Addendum #7

CONSIDER IN YOUR RESPONSE/BID THE FOLLOWING ITEMS OF ADDITION, DELETION OR CLARIFICATION. INDICATE IN THE SPACE PROVIDED ON THE RESPONSE/BID FORM THAT YOU HAVE RECEIVED AND INCLUDED FOR THE REQUIREMENTS OF THIS ADDENDUM. SICKKIDS MAY, IN ITS SOLE DISCRETION ANSWER SIMILAR QUESTIONS FROM VARIOUS RESPONDENTS ONLY ONCE.

RE: QUESTIONS AND ANSWERS, SPECIFICATIONS, DRAWINGS AND DOCUMENTS

MP 02 EW 01

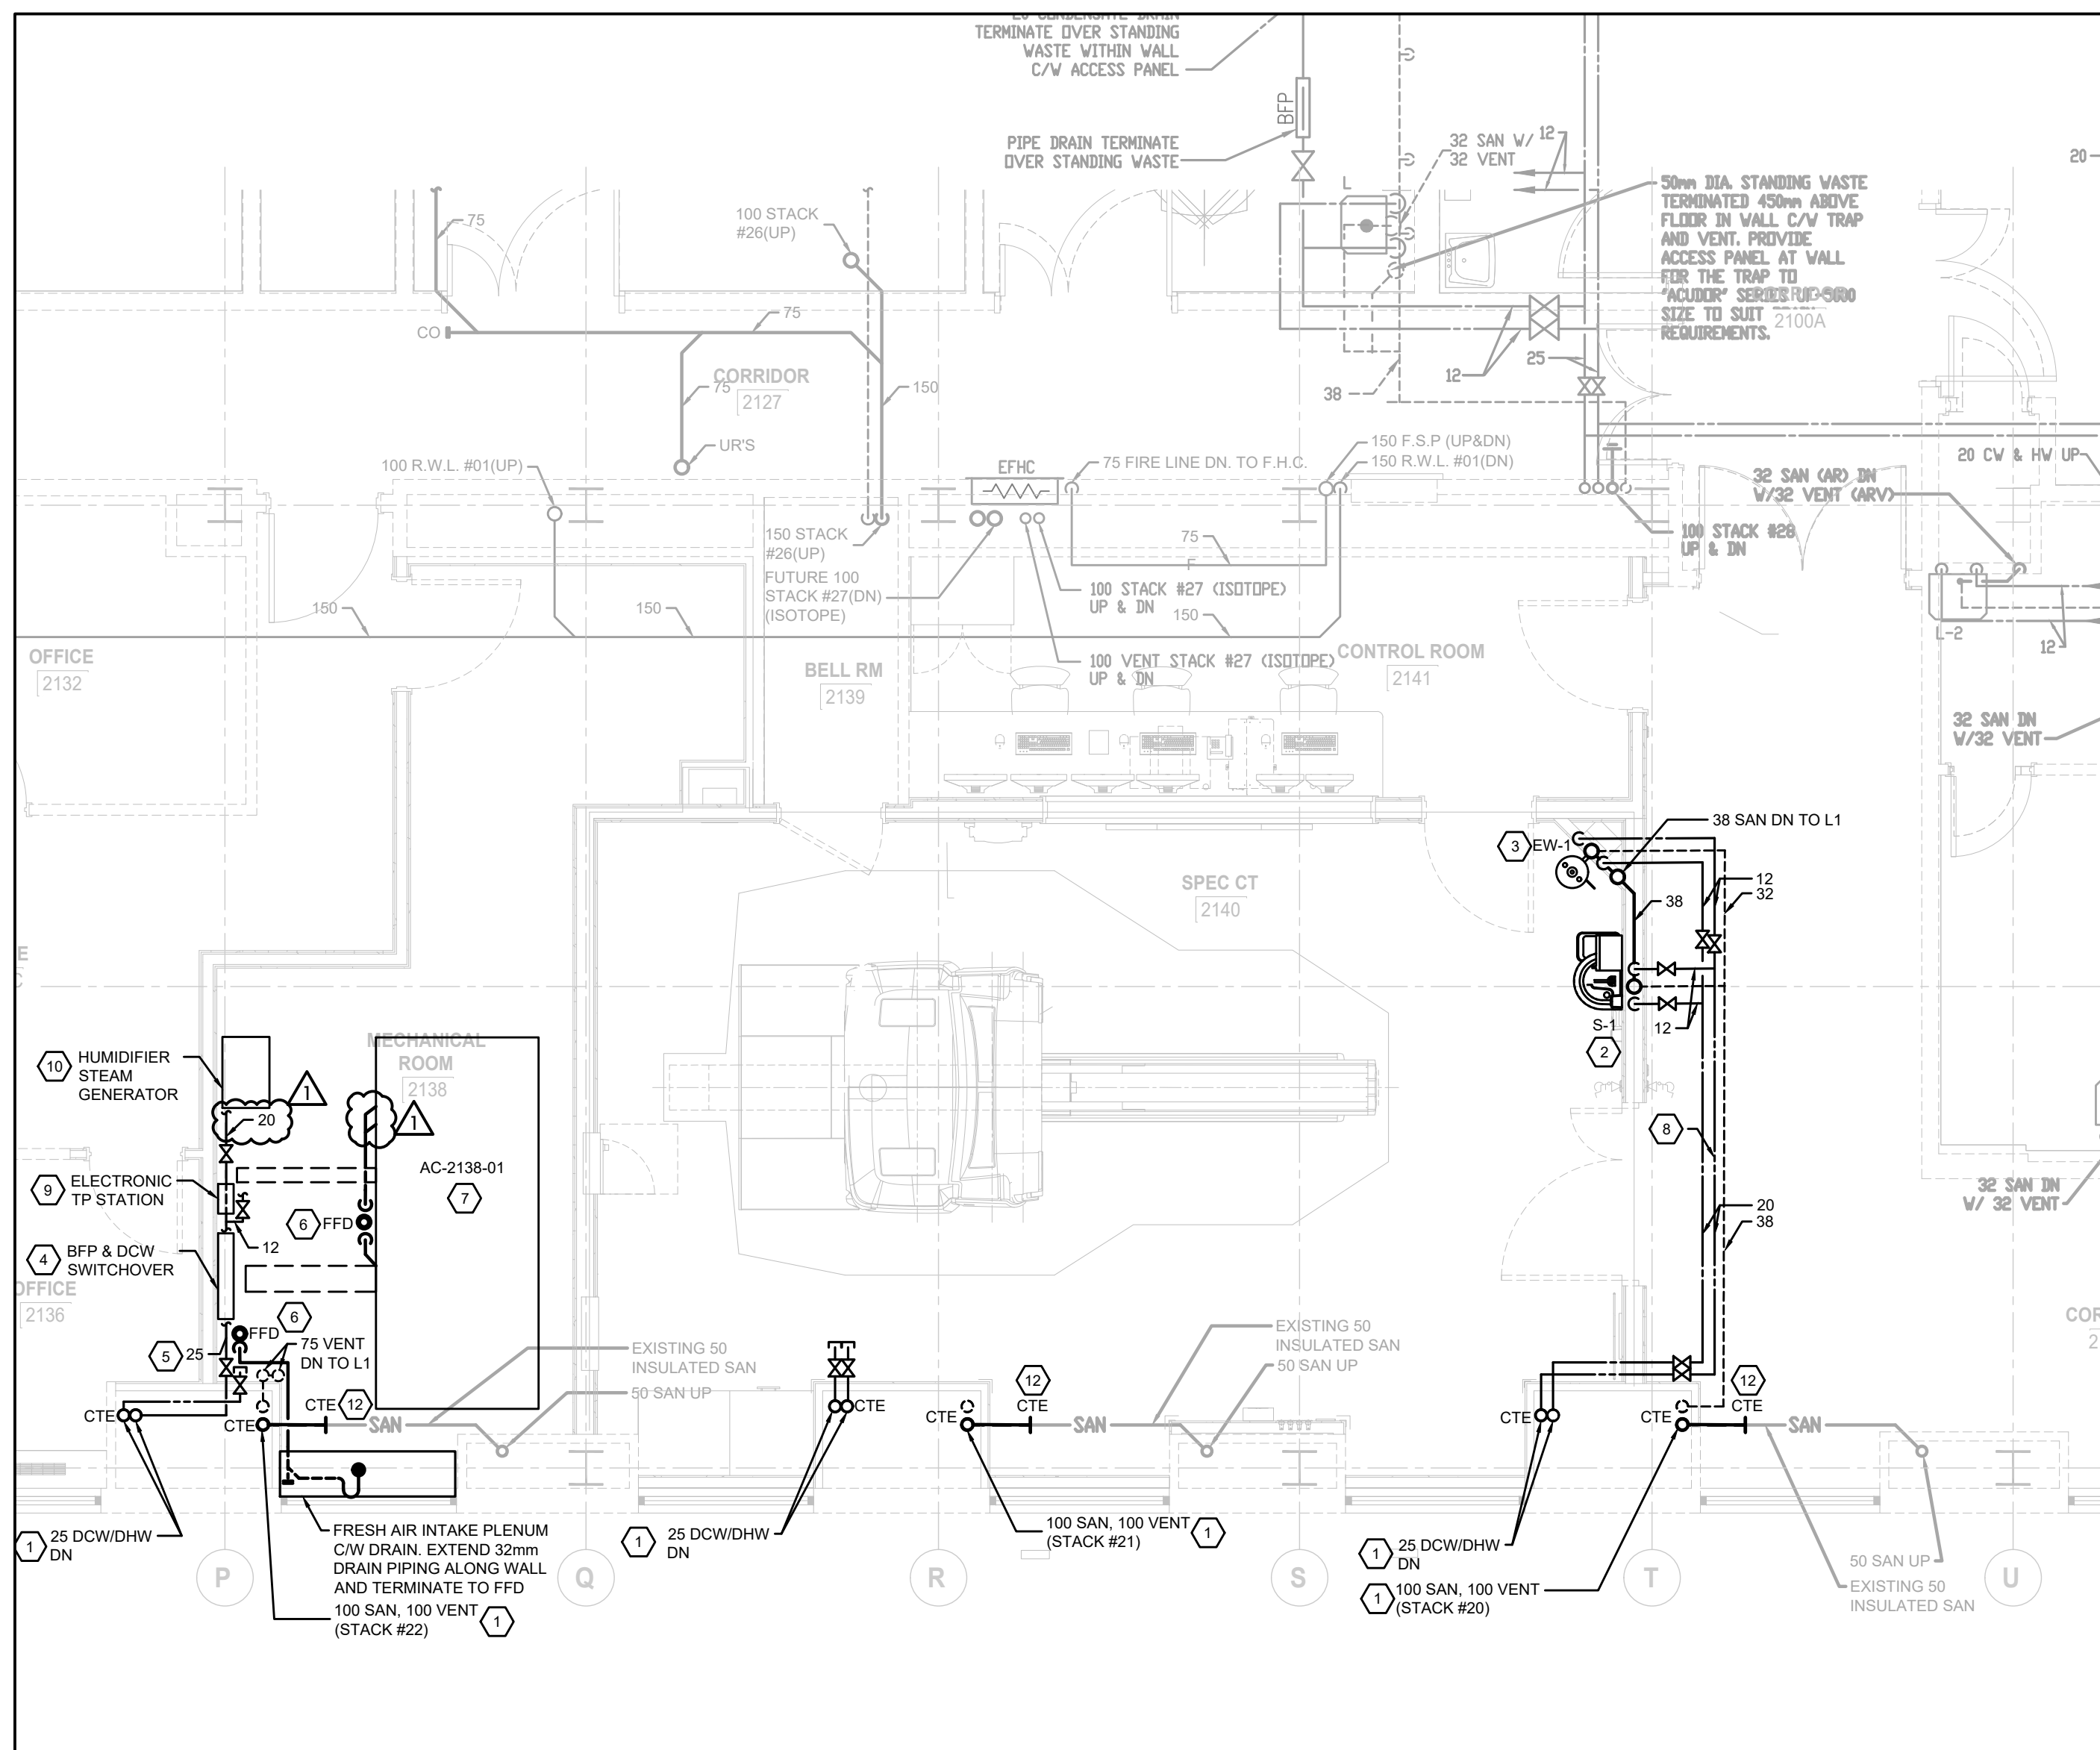
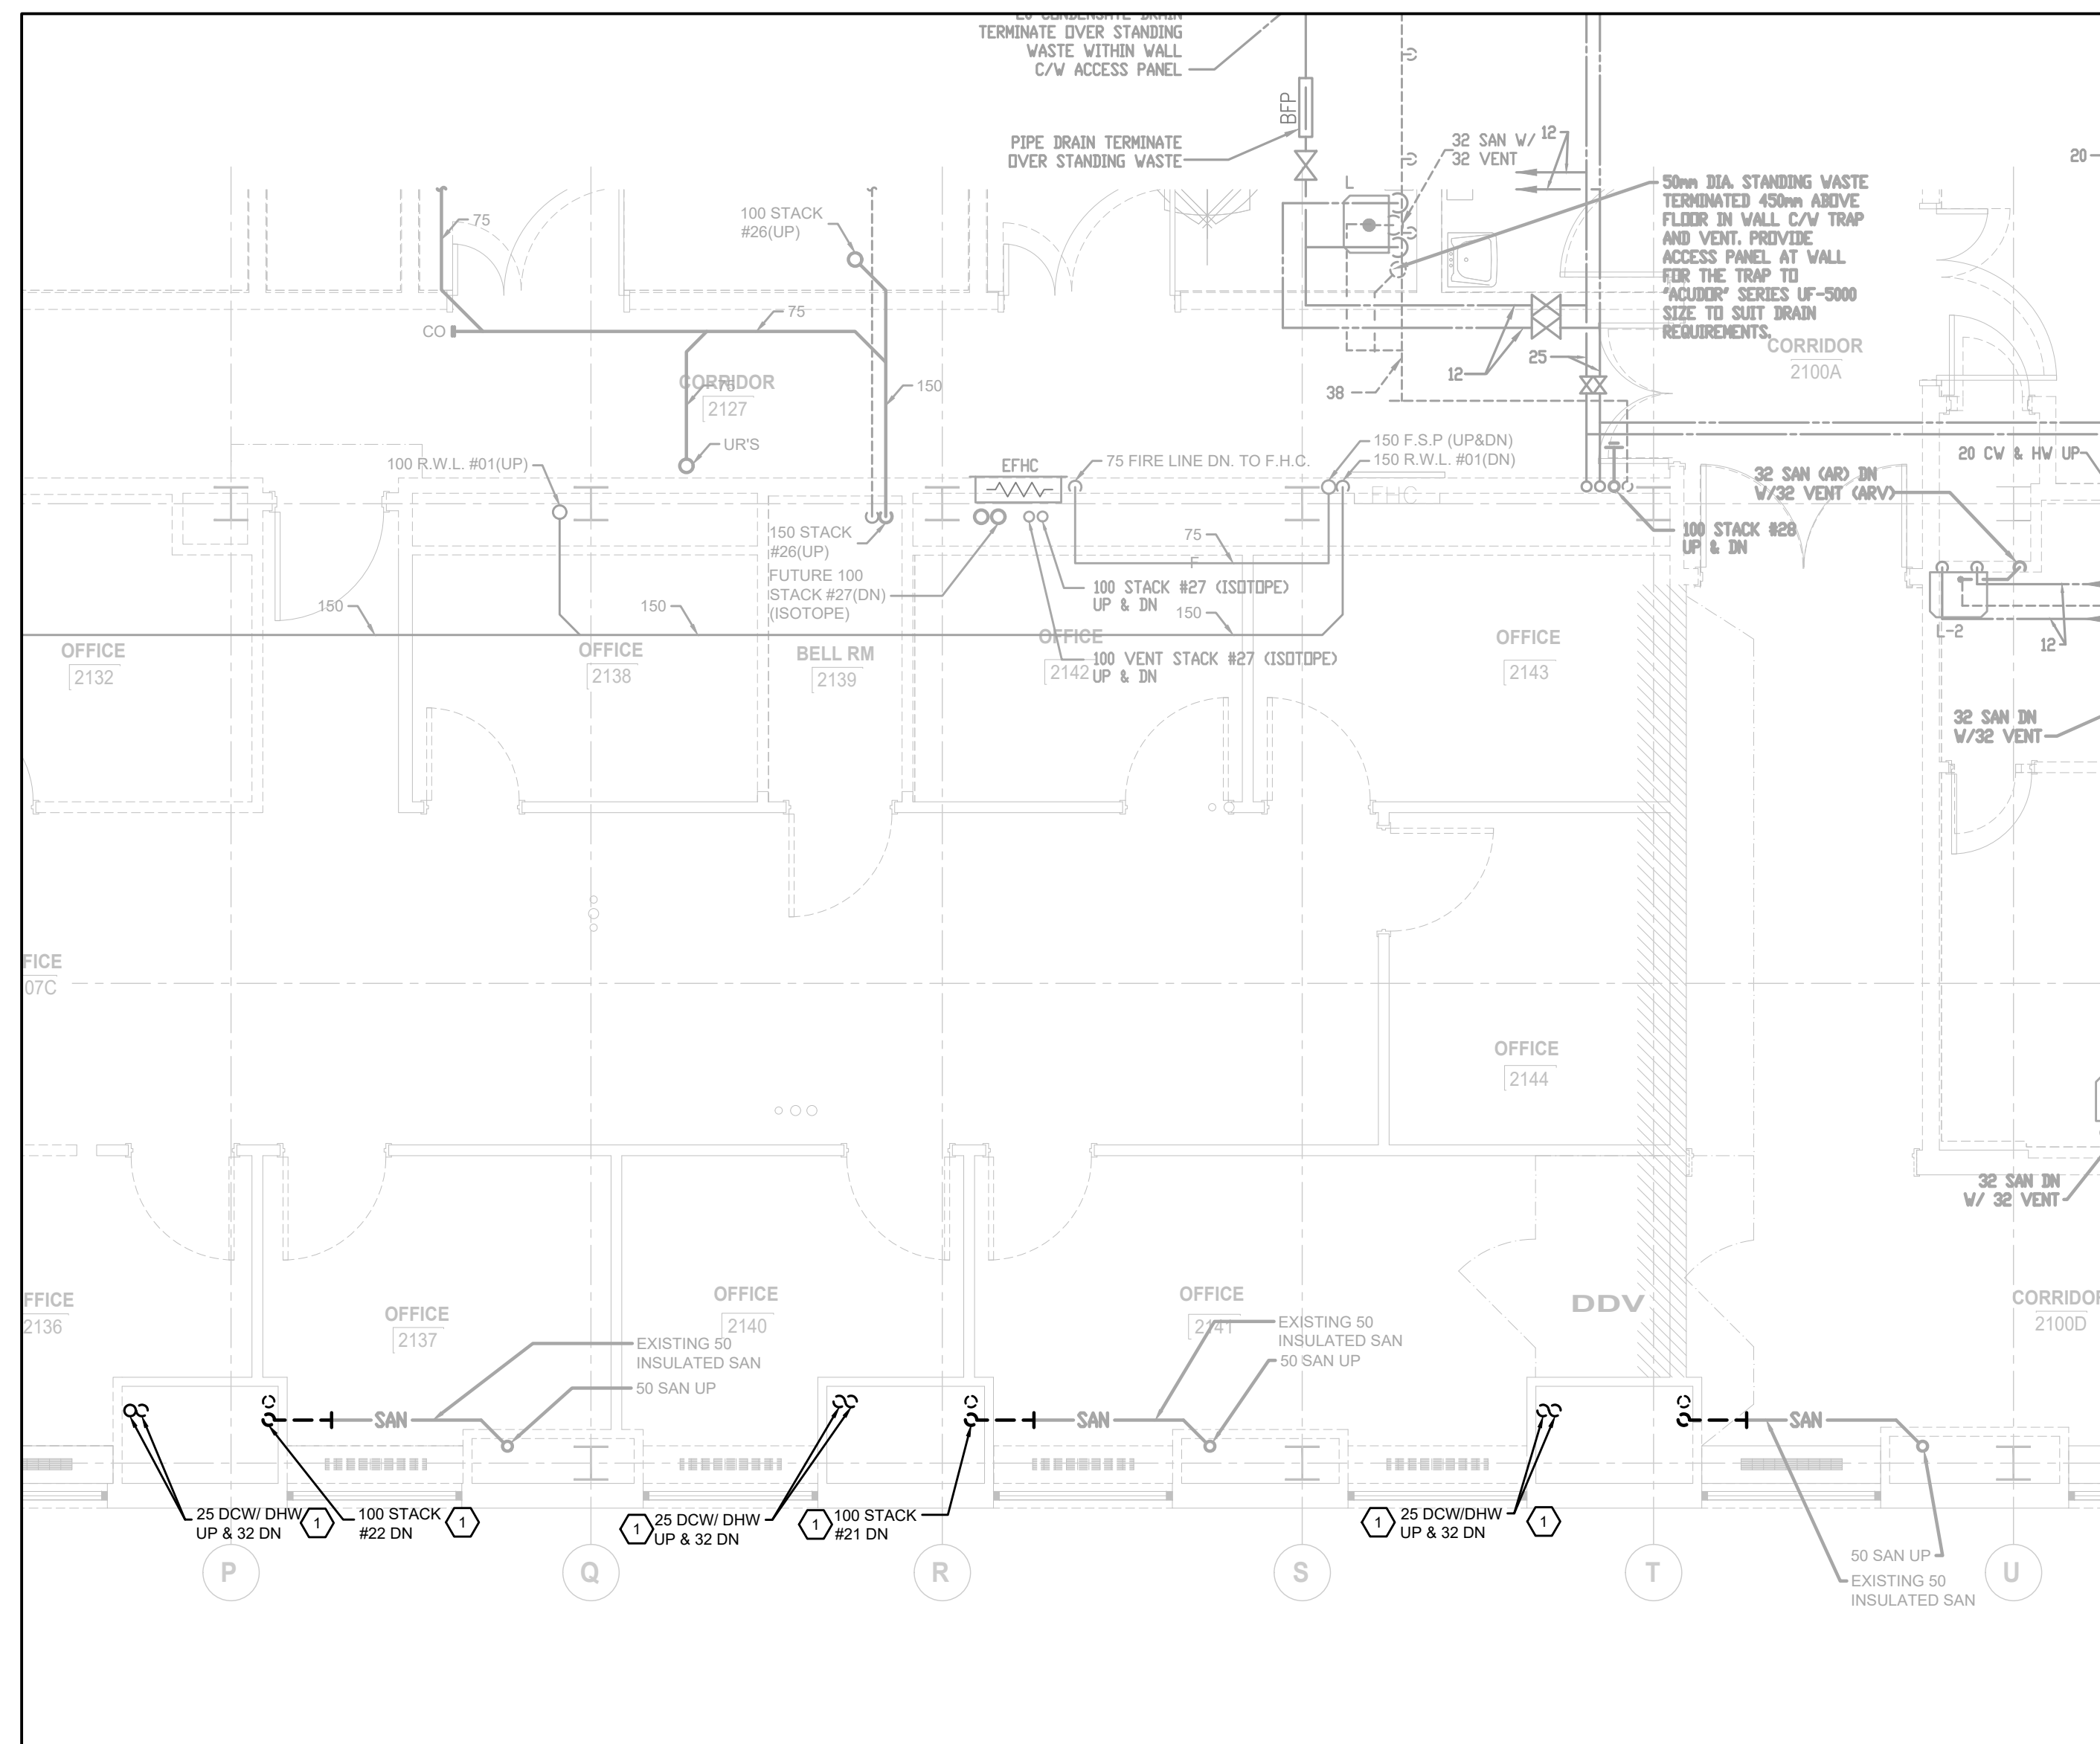
- Revisions to domestic water pipe size.
3. **Drawing MP 02 EW 01 – LEVEL 2 PART PLANS – PLUMBING – DEMOLITION AND NEW WORK.**
 - Revisions to drawing sheet keynotes.

- Revisions to new work plans.
4. **Drawing MG 02 EW 01 – LEVEL 2 PART PLANS – MEDICAL GAS – DEMOLITION AND NEW WORK.**
 - Revisions to ZVB/AP location and associated piping.
